Attachment A

Copy of Submission

From: [Anthony Boskovitz](#)
To: [Julie Terzoudis](#); [Peter Magiros](#)
Cc: [DASubmissions](#)
Subject: RE: Site visit request - Development application ref: D/2023/878 - St Vincent's College, 1 Challis Avenue, Potts Point
Date: Tuesday, 9 July 2024 3:51:04 PM
Attachments: [~WRD2745.jpg](#)
[image001.png](#)
[image002.png](#)
[Methodology Statement July 2024.pdf](#)
[2024.07.08_Challis Ave-21 23 Potts Point\(1\).pdf](#)

St Vincent's College . Potts Point _Proposed modification to DA submission

TITLE: Level 3 Plan
 SCALE: 1:150 @ A1
 ISSUE: [Date]

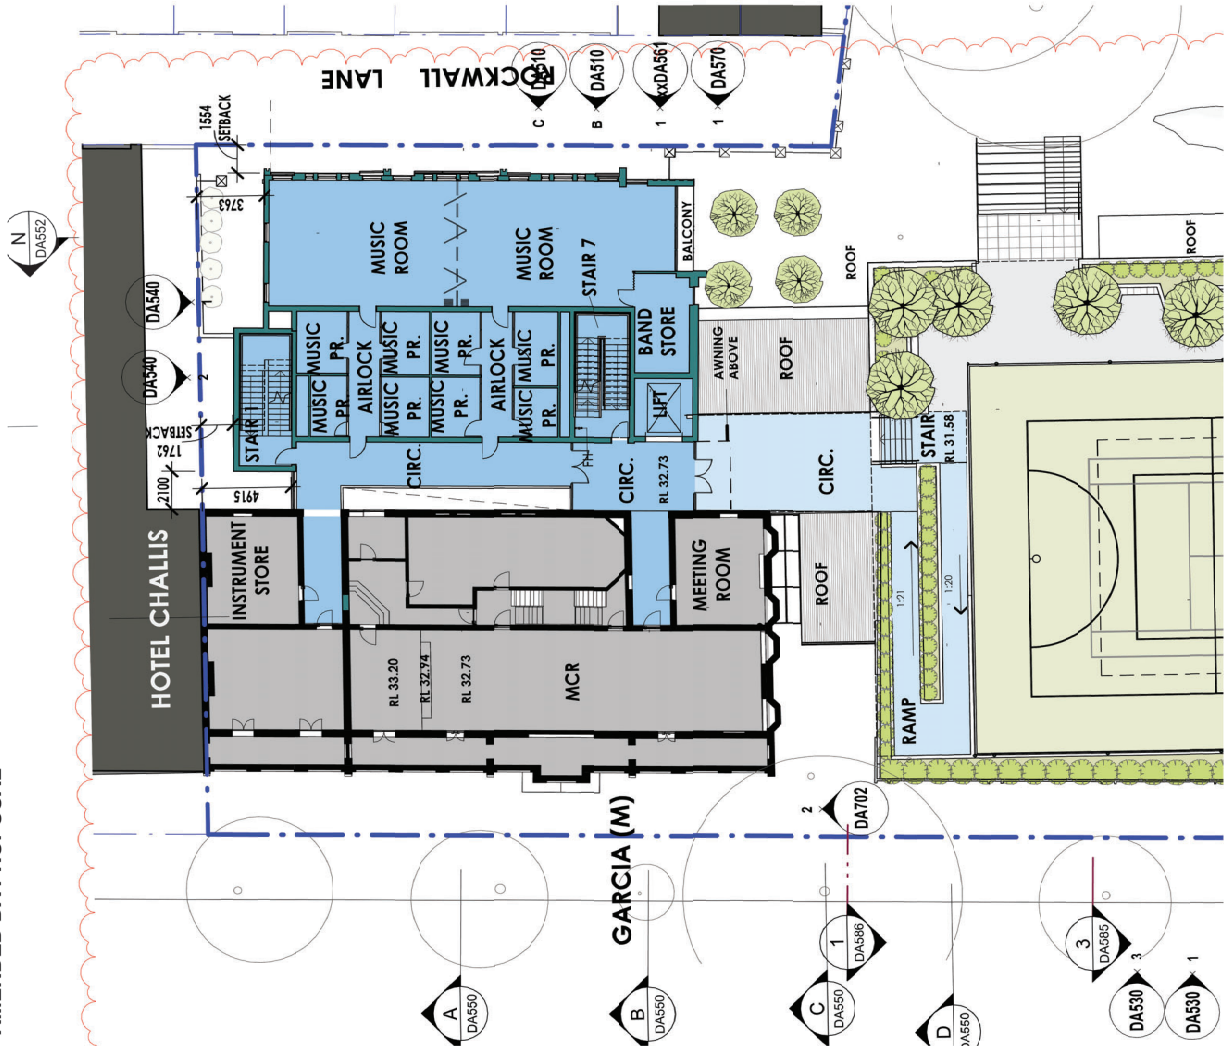
Our initial investigation suggests that there is a very pronounced inefficiency in the zone of the foyer on the western end of Garcia.

We have focused on rationalisation of that space and with a simple reorientation and relocation of the vertical core we have been able to shift the rear extension to be in line with the west face of Garcia

Our initial calculations indicate that the separation that can be achieved would be in part 3 and in part 6.5 meters, which is sufficient for a reasonable landscape space with small size trees.

TITLE
 Level 4 Plan
 SCALE
 1:500 @ A1
 ISSUE
 AMENDMENT NO. 02
 PREPARED BY

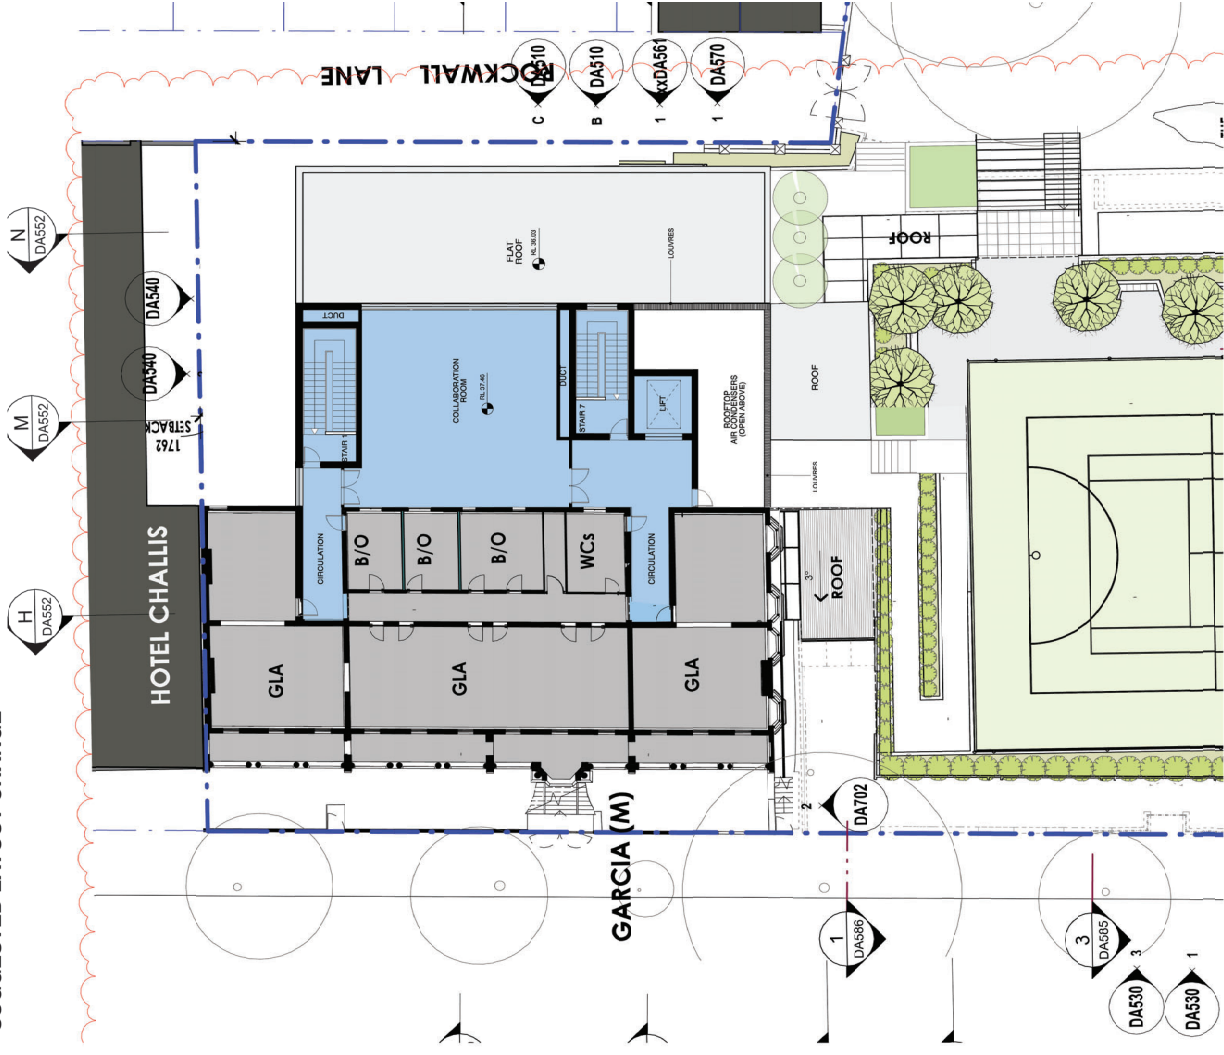
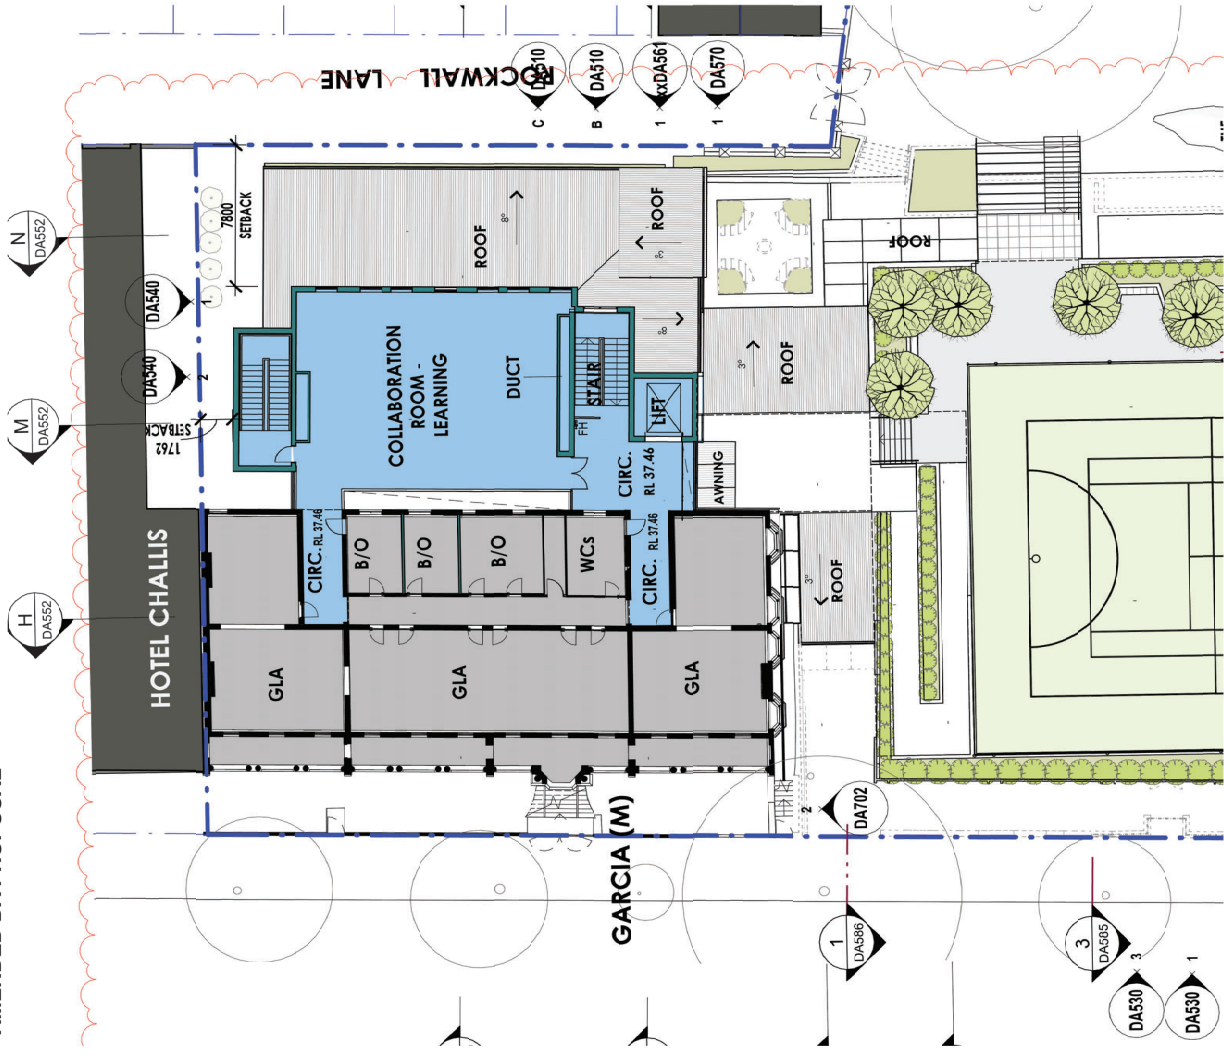
To achieve that we had to relocate the Collaboration Room from Level 5 to Level 4. While in doing that we have lost about 40m² and reduced it from 170 to 130m², we believe that there is ample space available to compensate for the apparent shortfall.

TITLE
 Level 6 Plan
 SCALE
 1:650 @ A1
 DATE
 11/01/2024
 DRAWN BY
 YH
 CHECKED BY
 CH

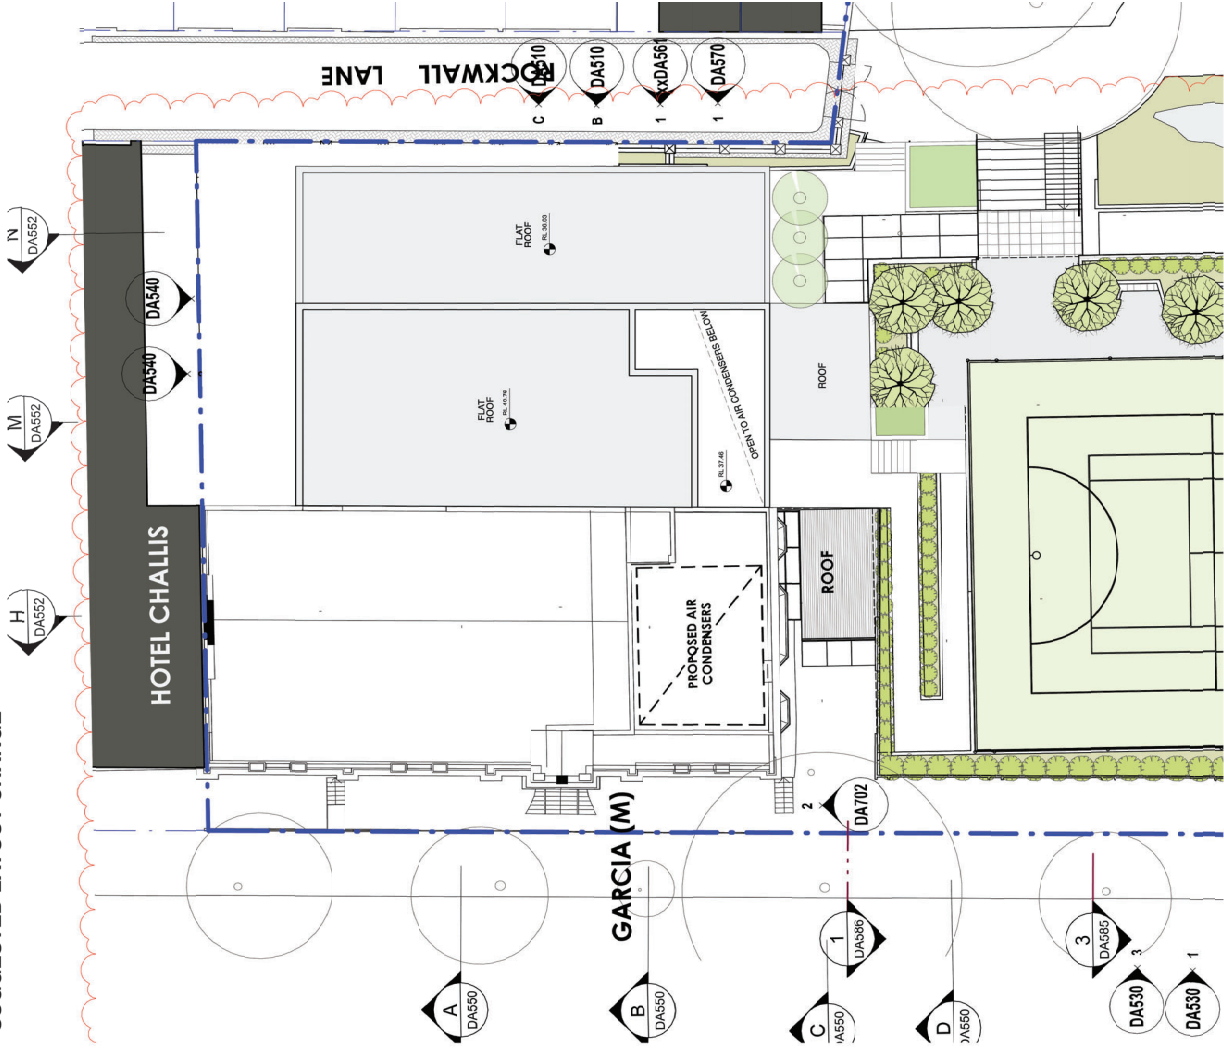
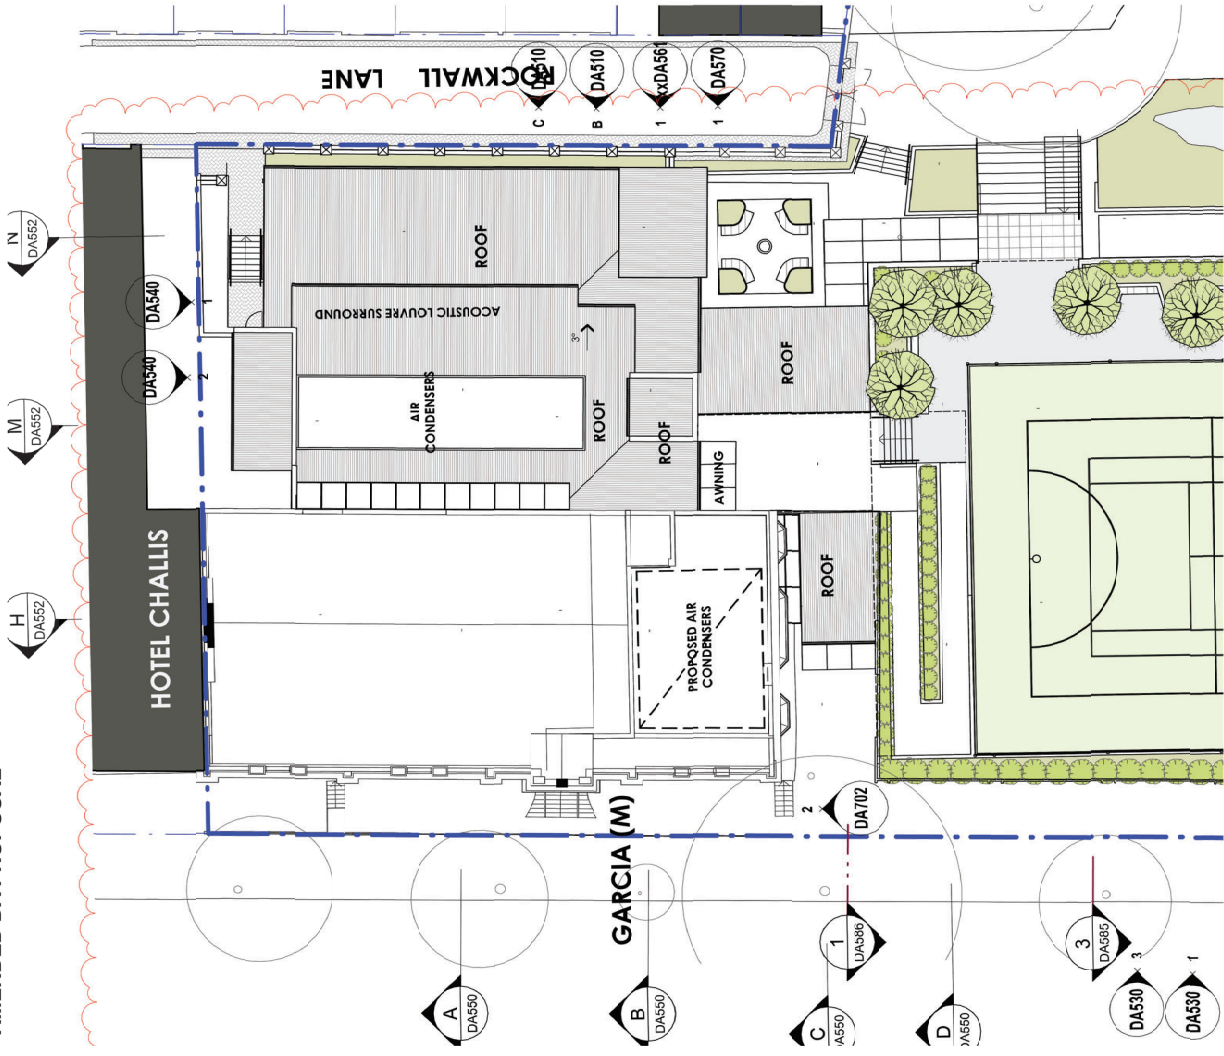
More importantly we have also managed to relocate the proposed Plant Room from Level 6. The suggestion is that the plant be relocated to the space along the south facade of the Multipurpose Court building, facing the Middle Courtyard. This is a large facade that can be well ventilated. Having it centrally located would assist with the likely acoustic impacts on the residential properties along Rockwell Lane and it would clean the associated visual noise.

From technical point of view the remote Plant Room can work in this location. Our understanding is that a high end multi VRV systems can have up to 90m between the condenser and the fan coil units, which here would be the sufficient.
